FINAL PLAT OF WINDEMERE

AN ADDITION TO WICHITA, SEDGWICK COUNTY, KANSAS

WINDEMERE

Re: S/D 85-41 - Final Plat of Windemere Addition

FINAL PLAT

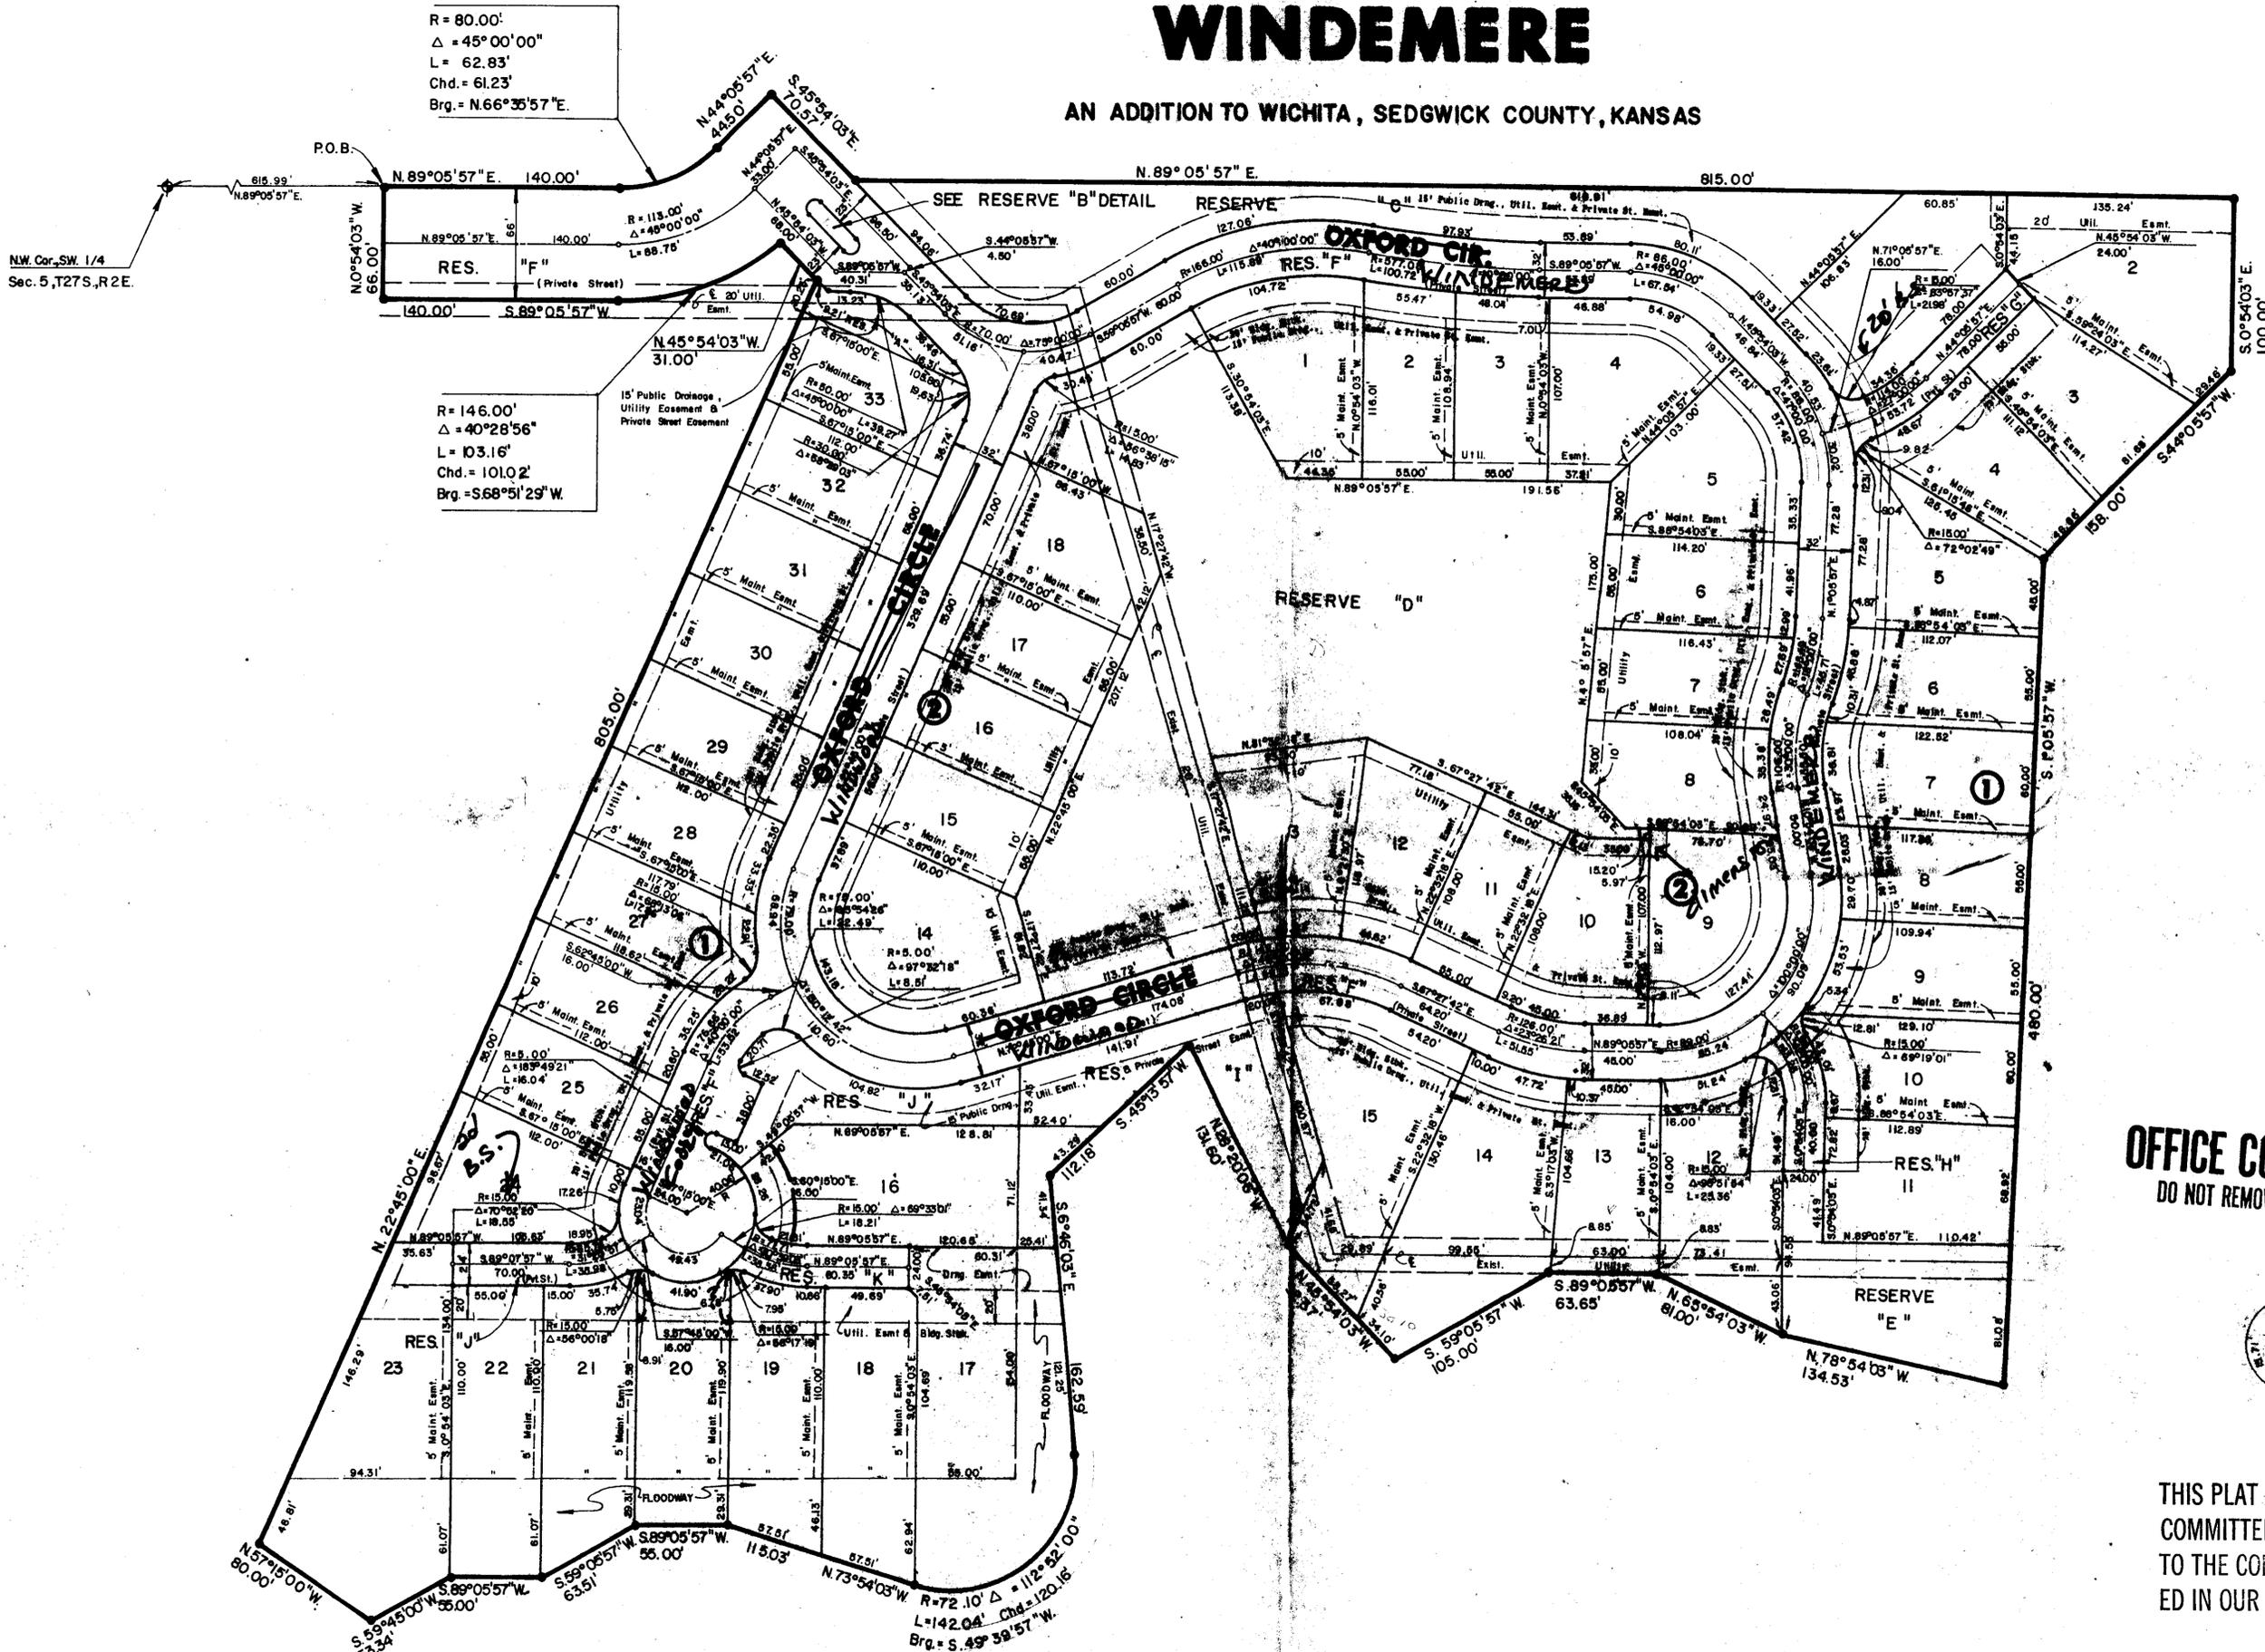
~~H.~~ On the final plat tracing, Oxford Street shall be labeled in the north-west corner of the plat.

~~L.~~ The final plat tracing shall indicate the minimum building pad (required by the applicant's drainage plan) on the lots surrounding Reserve "D".
Vickie ok'd 7/11/85 FCN

- ~~O.~~ The final plat tracing shall label the 20-foot building setback on Lots 1 and 24, Block 1.
- ~~P.~~ The final plat tracing shall indicate a 20-foot building setback on Lot 16, Block 1.

- ~~Q.~~ The final plat tracing shall dimension the utility easement in the north-west corner of Lot 9, Block 2.
- ~~R.~~ The final plat tracing shall dimension the utility easement and building setback being platted on the front of Lot 20, Block 1.

- ~~S.~~ The final plat tracing shall indicate the recording information for the existing 20-foot utility easement that crosses this property.
- ~~T.~~ On the final plat tracing, the platlor's text shall be amended to reference that Reserve "F" is being platted for private street purposes.

- ~~U.~~ At the time this plat was considered in preliminary form, the street name "Oxford Circle" was suggested by several members of the Utility Advisory Committee. After checking with the Office of Central Inspection, it has been learned that, if all streets within this addition are named Oxford Circle, an address numbering problem will be created. The following street name changes shall be indicated on the final plat tracing:

1. East/west street from Reserve B to Reserve H - WINDEMERE (alternate for 25th Street North).
 2. East/west street from Reserve H to north line of Lot 33, Block 1 - WINDWOOD.

3. Cul-de-sac serving Lots 16 thru 26, Block 1 - WINDWOOD COURT.
- ~~V.~~ Closure computations shall be submitted with the final plat tracing.
- W. Recording of the plat within 30 days after approval by the Board of City Commissioners.
